Chapter 9: Slope, Survey, Scaling, and Boundary Defects

Section A — Steep Slopes (Significance & Misclassification)

Section B — Inadequate Site Plan & Partial Boundary Verification (No Stamped Survey of Record)

Figure A1: Poverty Flats Site Plan showing proposed location of cultivation sites in relation to ridge lines and property boundary. Note: None of the cultivation sites are on the top of the ridge lines as claimed in the MND.

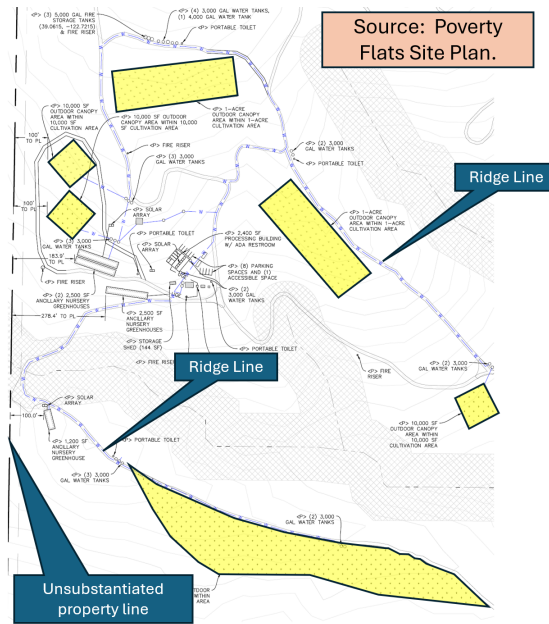
1. **The record admits steep terrain—and the site plan’s own pad/road placements contradict the “flat ridgetop” claim..**

The IS/MND reports an average slope of ~39.5%, and the Property Management Plan describes southern-aspect sloping montane topography—both incompatible with a “flat ridgetop” characterization [A4][A5]. In addition, the site plan locates multiple cultivation pads, access roads, and fencing lines along south- and southwest-facing hillslopes below the ridgeline, with contour spacing that reflects steep grade bands (e.g., 30–50% and greater) rather than level ridgetop benches (Figure A1, A2, A3, A4). Several features would require cut/fill and slope-length breaks to achieve workable grades, which further confirms the on-slope siting. Taken together, the file’s own drawings place project elements on steep slopes, directly contradicting the narrative assertion that cultivation areas are “flat, ridgetop areas” and triggering the need for slope-responsive analysis under CEQA. [A11][A12][A4][A5] [A6]

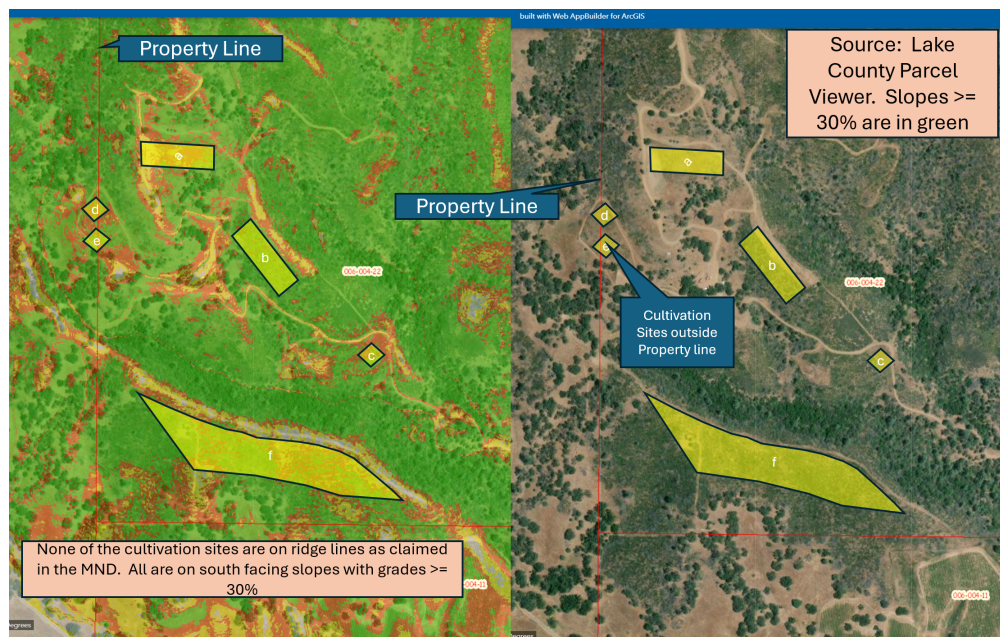
Figure A2: Poverty Flats cultivation sites overlaid onto Lake County Parcel Viewer maps with slope overlay. Note slopes in green are >=30. Note: viewer-based overlay indicates slopes $\geq 30\%$. Viewer alignment suggests Sites “c” and “d” may not be fully inside the parcel; confirmation requires a stamped boundary survey.

Viewer-based overlays indicate areas of close proximity to parcel lines and

potential encroachment for two cultivation sites (Figure A2, A3). Because the western boundary has reportedly been field-verified, uncertainty may be reduced along that edge, but there is no stamped survey of the remaining parcel boundaries or the disturbance polygons. Accordingly, encroachment cannot be confirmed or ruled out without a complete, stamped boundary (and topographic) survey. The County Surveyor has already instructed that Parcel Viewer lines are not acceptable for legal parcel boundaries or setbacks and that a professional survey must control setback measurements. Separately, BLM has required a professional survey to confirm the project's position relative to federal lands. Until a stamped survey demonstrates that each cultivation polygon and associated grading/fencing lies entirely within the legal parcel and outside all required buffers, any "less-than-significant" finding that depends on boundary geometry remains speculative under CEQA.

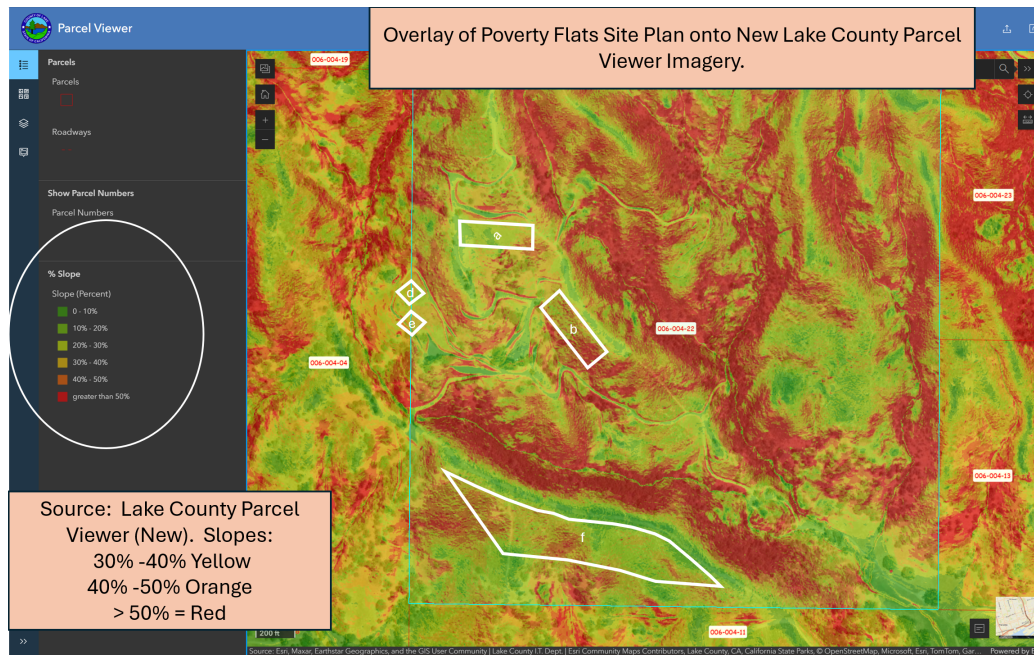
Figure A3: Poverty Flats cultivation sites overlaid onto Newer version of Lake County Parcel Viewer maps with slope overlay providing more detail. Slopes in yellow are 30% to 40%; Orange 40%-50%; Red > 50%. Sites “b” and “f” are intersecting slopes >50% -- not allowed by WCB. Also Sites “b” and “f” intersect ≥50% slopes under the viewer-based overlay (not allowed by Water Board Tier-2). Viewer alignment also suggests Sites “c” and “d” may not be fully within the parcel; this cannot be confirmed or ruled out without a stamped boundary survey.

Figure A4: USDA soil map survey of Poverty Flats approximate cultivation locations. Note: All locations exceed 30% grade and are on soils with “high to severe” erosion risk.

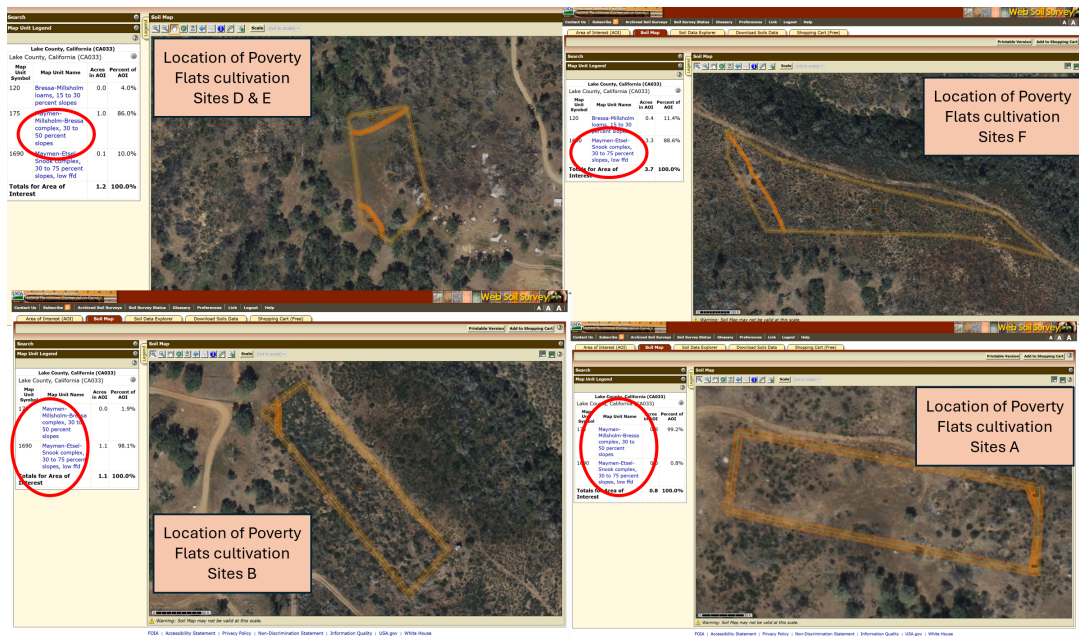
Site-plan overlays and USDA soil mapping place cultivation polygons across 30–50% and 50–75% slopes, on units the Clear Lake Nutrient TMDL identifies as severe erosion hazard (e.g., Maymen–Etsel–Snook 30–75% (severe); Maymen–Millsholm–Bressa 30–50% (severe)), confirming high potential for sediment delivery absent robust controls [A14] (Figure A4).
